PLANNING, ZONING, & BUILDING DEPARTMENT
PZ&B Staff Combination Memorandum: Architectural Commission and Town Council

SUBJECT: ARC-24-0015 (ZON-24-0008) 253 SEMINOLE AVE (COMBO)

MEETING: AUGUST 28, 2024 ARCOM
SEPTEMBER 11, 2024 TC

Area of Work

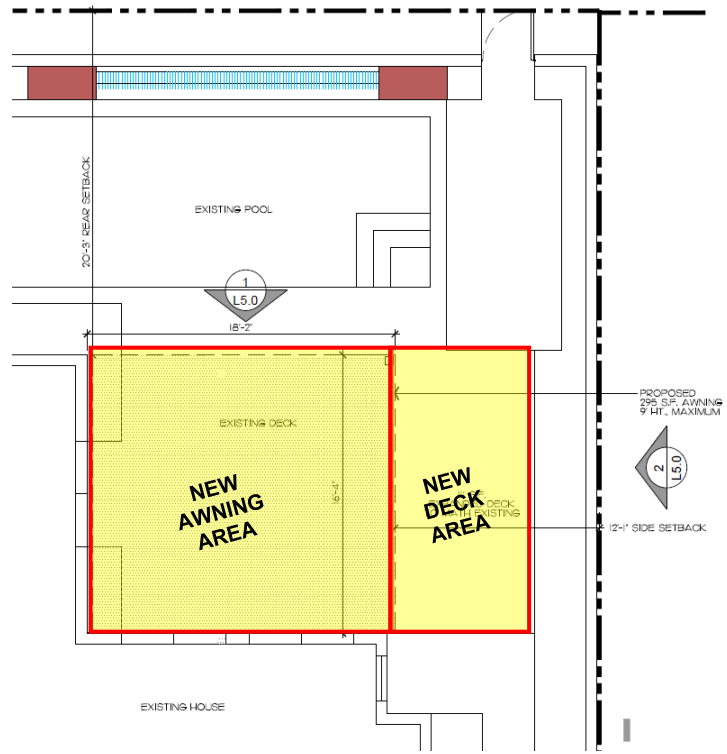
The applicant is proposing the construction of a new canopy awning structure with a related hardscape expansion at the rear of the property at the pool deck. A preliminary review of the project indicates that the application, as proposed, is inconsistent with the Town zoning code and requires two (2) variances to achieve the application as proposed.

The subject property is one-half of a duplex located on the north side of Seminole Avenue. The proposed awning addition is 295 SF and is proposed over existing decking and planter areas at the rear of the structure. The height of the awning will not exceed 9' in height. The applicant is also proposing to expand existing hardscape to the east by removing sod and installing 111 SF of acid washed white cast stone to match existing deck materials. No other landscape changes are proposed. The site is nonconforming to both lot coverage and landscape open space regulations as it exists. The proposed changes exacerbate the nonconformities and require variances from the zoning code.

New Awning and Hardscape Area Enlarged

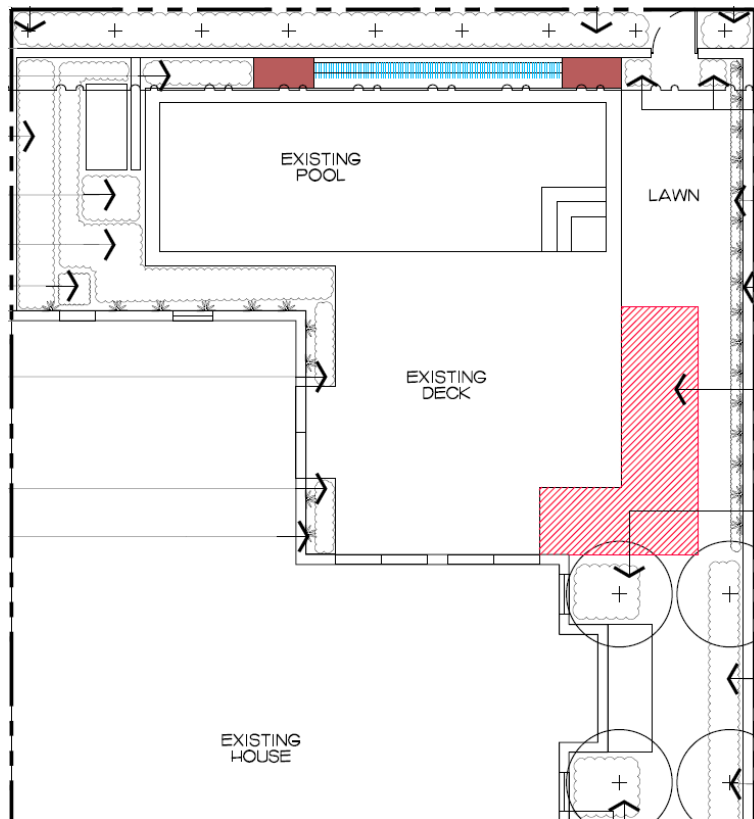
Landscape area (sod) to be removed.
